IEEE P802.11 Wireless LANs

LB276 CR for OST CIDs (11.5.1 Sensing Procedure) – Part 2									
	Date: 2023-10-13								
Author(s):	Author(s):								
Name	Affiliation	Address	Phone	email					
Stephan Sand	German Aerospace Center (DLR)			stephan.sand@ieee.org

This submission discusses resolutions to the following 15 CIDs from LB276 of TGbf D2.0. The CID list is: 3002, 3037, 3038, 3046, 3048, 3049, 3050, 3051, 3052, 3053, 3054, 3055, 3073, 3162, 3204

Figure 11-75a—Sensing measurement session state machine diagram

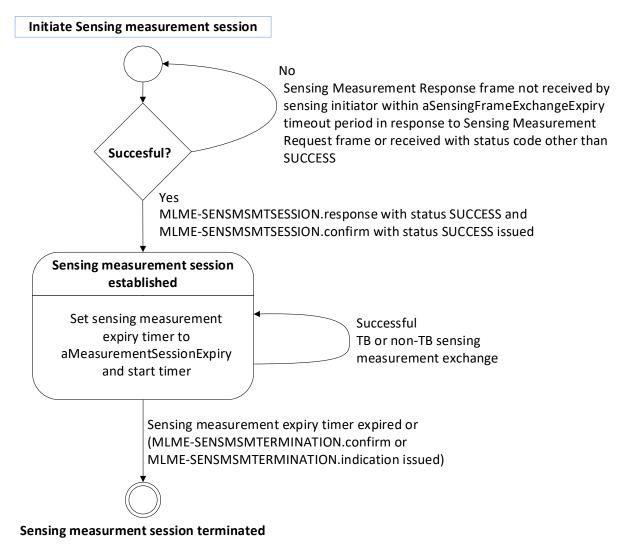
3073	You-Wei Chen	E	142.18	add abbreviations (SMS, SMS timer) in Figure 11-75a to 3.4?	add abbreviations (SMS, SMS timer) to 3.4	Rejected Removed abbreviations SMS in Figure 11-75a
3052	Robert Stacey	Т	142.29	A shall statement conditional on intent is not testable and thus not useful	Replace with "An unassociated STA establishes a sensing measurement session for non-TB sensing measurement exchanges by transmitting a Sensing Measurement Request frame that includes a Non-TB Specfiic element to the AP."	Revised TGbf Editor: Please replace the paragraph on P142L38 with "An unassociated STA establishes a sensing measurement session for non-TB sensing measurement exchanges by transmitting a Sensing Measurement Request frame to the AP including a Non-TB specific element to set the parameters of the sensing measurement session."
3053	Robert Stacey	Т	142.34	A shall statement conditional on intent is not testable and thus not useful	Replace with "An unassociated non-AP STA solicits sensing measurement session establishment by sending a Sensing Measrement Query frame to the AP."	Revised See also CID 3049 <u>TGbf Editor:</u> Please replace the sentence starting on P142L43 with "An unassociated non-AP STA solicits sensing measurement session initiation by issuing an MLME- SENSMSMTQUERY.re quest primitive that results in the transmission of(*23/1486r1) a Sensing Measurement Query frame to the AP."
